HISTORIC LANDMARK COMMISSION APRIL 10, 2017 APPLICATION FOR A CERTIFICATE OF APPROPRIATENESS LHD-2017-0003 4012 Avenue G Hyde Park

Construct a two-story rear addition to a one-story bungalow.

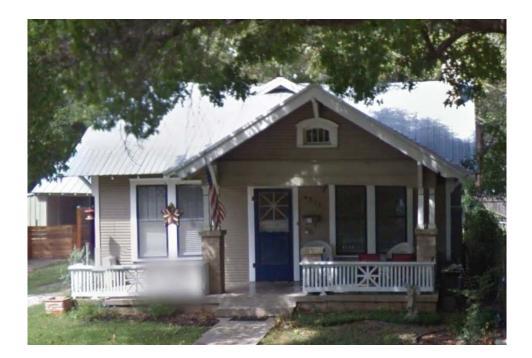
<u>**3.2.2.**</u> Choose a replacement door that is compatible in terms of design and appearance with the historic character of the house.

<u>**3.2.3**</u>. Retain original glazing configuration for door.

<u>**3.3.4.**</u> Consider replacement windows which more closely reflect the existing 3/1 configuration, or otherwise feature articulation appropriate to the existing house. Omit the projecting glass window box on the south elevation and retain original glazing configuration and profile.

<u>4.1.</u> While the addition does not affect the historic fabric of the existing façade and replaces a non-historic rear addition, consider revisions to form/massing to maintain proportionality with existing. The west side of Avenue G is comprised of mostly one-story structures which retain a low profile and do not have highly visible additions from the street.

<u>4.2.</u> The addition is located to the rear side of the building. If site permits, consider siting the addition further north or reduce its overall scale to minimize impact on the streetscape.

<u>4.3.1.</u> Consider reducing pitch of gable visible from street to match existing, or reducing overall roof height.

<u>4.3.2.</u> For windows visible from the street, consider a more regular fenestration pattern, configuration, and/or shape to maintain visual proportionality with original structure.
